MUNICIPAL ENGINEER'S OFFICE,

SKETCH

SHOWING COMPOUND WALL

ON PLOT NO 33 SHEET A 16

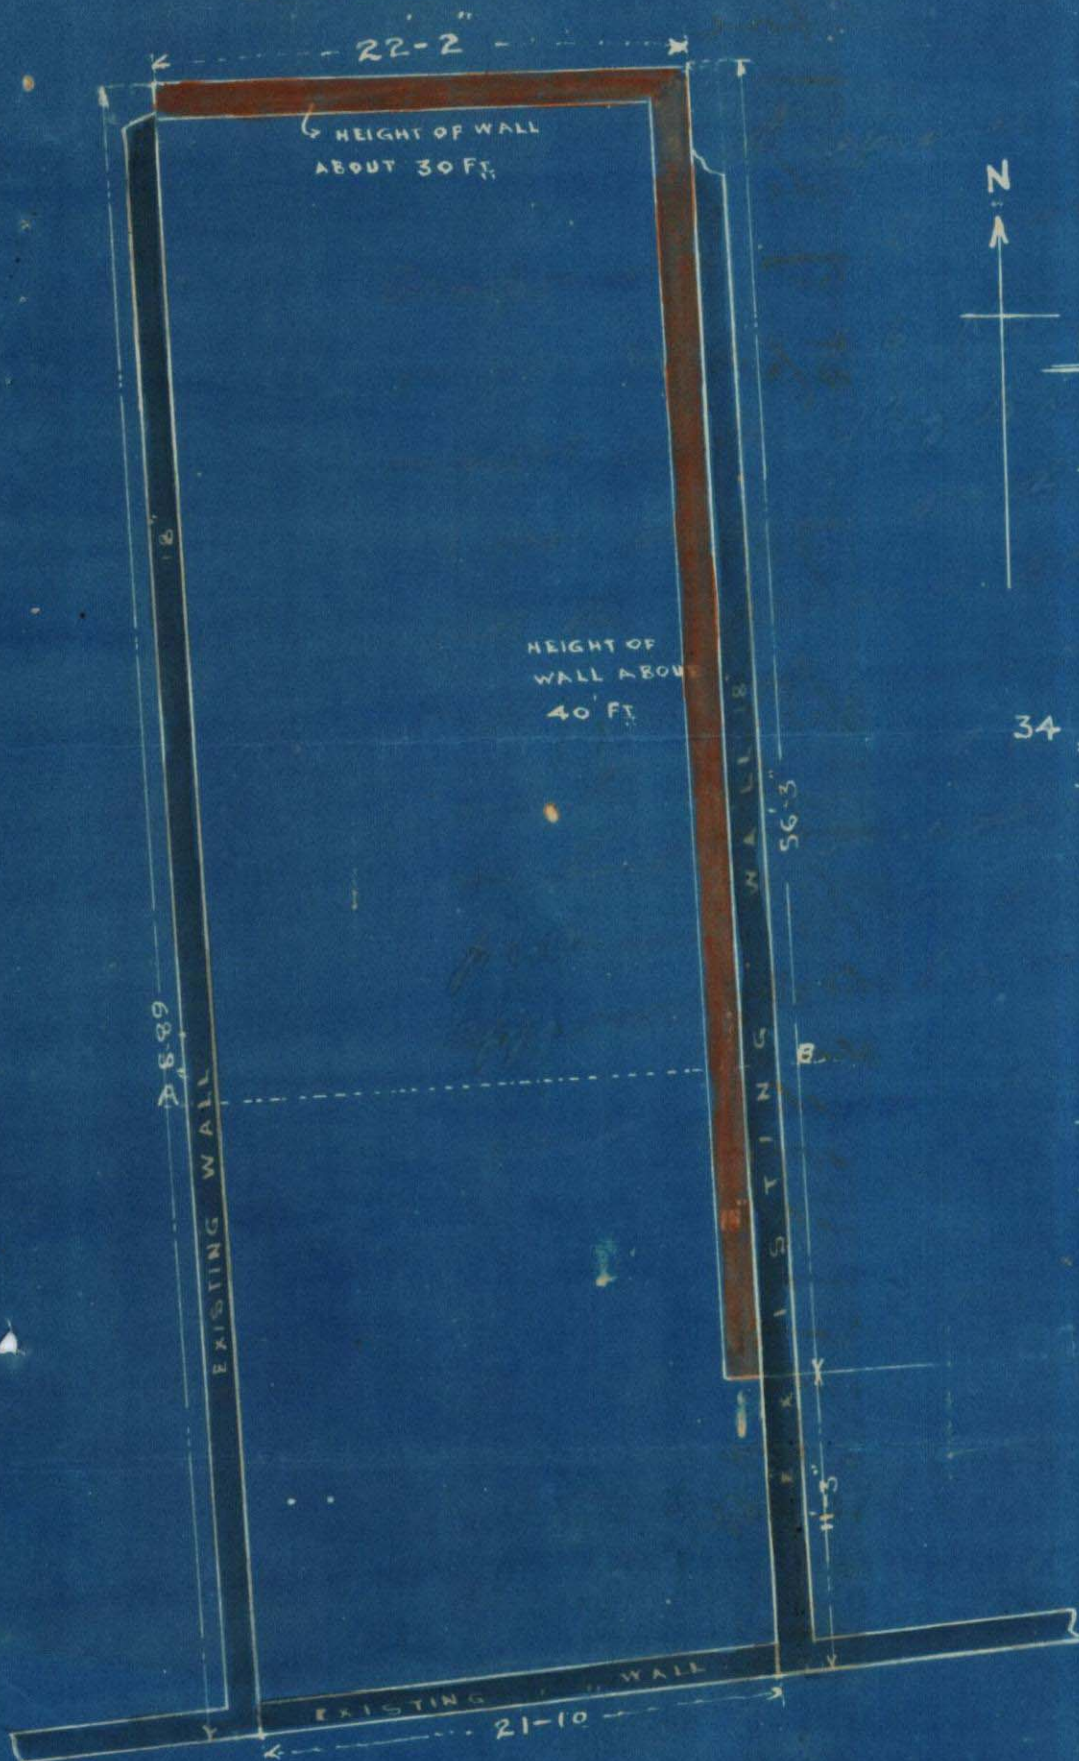
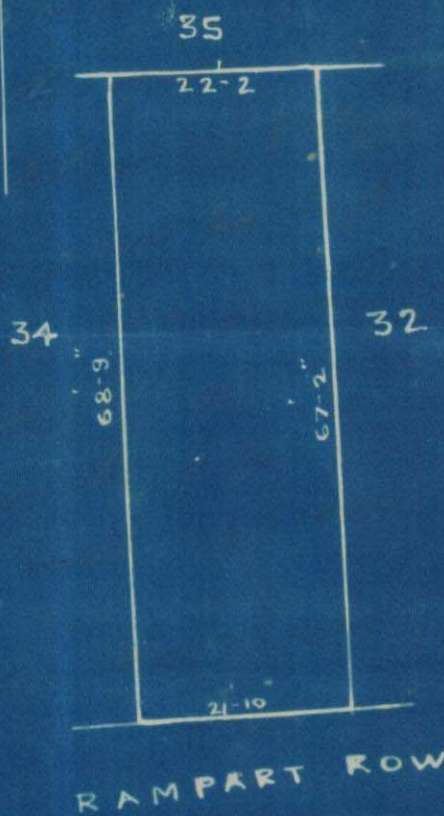
So from applicant
that walls 40-0" high of
the length, ^{+ thickness} shown would
be dangerous unless
supported by buttresses
or made thicker at the
bottom as explained
to him on the site.

And Prof. Ottens, they
to report - that it is
dangerous wall
a single wall of 30' or
40' height the thickness
is 8". It would have
been better if the
appl. will provide
thicker walls at the
bottom & thin top
walls.

Submitted to the Eng.
for order. The applicant
proposes to raise the
wall 4 or 5 ft height without
any buttress - which is
in ~~no~~ my opinion is
unsafe. You have
suggested him on the
spot to do certain ways
which are not been adopted.
Request your order.

Grant permission to erect
wall as per sketch

MARKET Q^R.

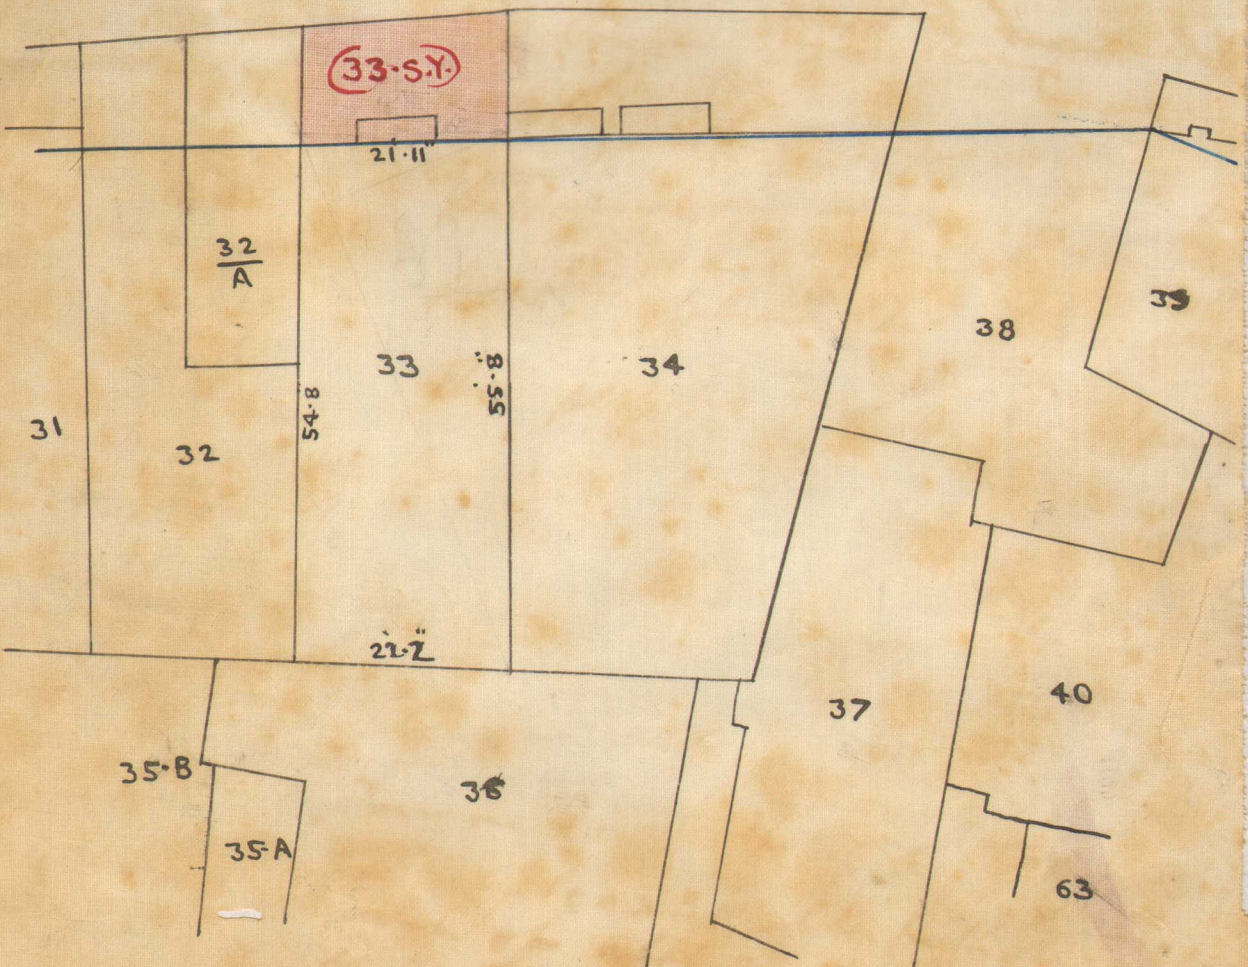
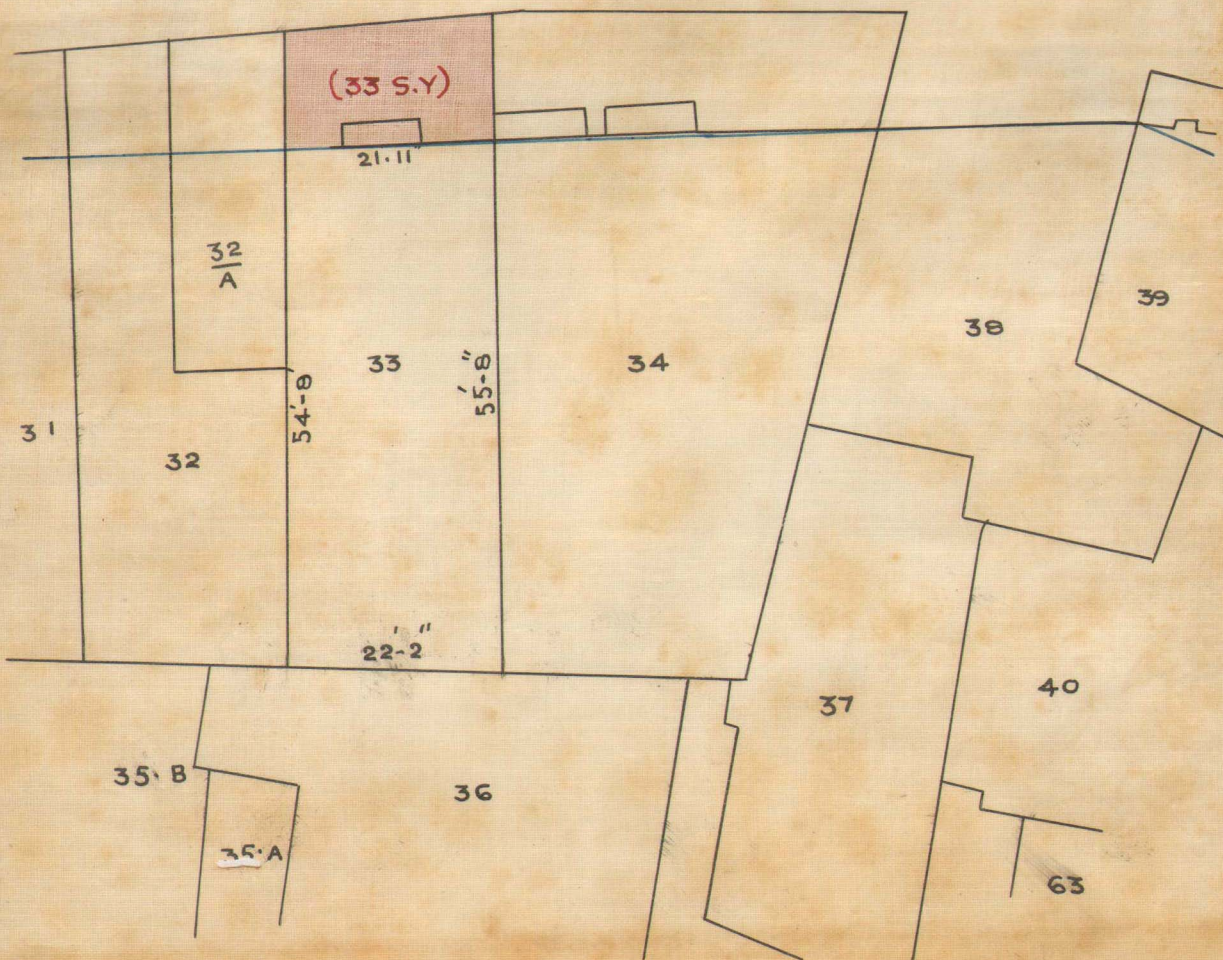
attached correspondence they
submit ~~subm~~ herewith a
Tracing showing in red the
portion of the plot Comes under
the original scheme. and request
to know whether ~~this is~~ ~~desired~~
as the Chief Officer and Chief Engr.
proposes to visit the Rampart
Row. when he has visited
the plot no 7 A¹⁵ Rampart Row
Bunker grade -

Forwarded to the C.O.V.C. for orders
The applicant Mr. Bethamand Drumann
owner of plot no 33 A 16 wishes to know
if the Municipality propose to acquire any
land from the above plot. A plan is
submitted showing the alignment line
laid down in 1900

In form applicant that permission is granted to build along ~~road~~ up to the alignment line as agreed with him on the ground this morning.
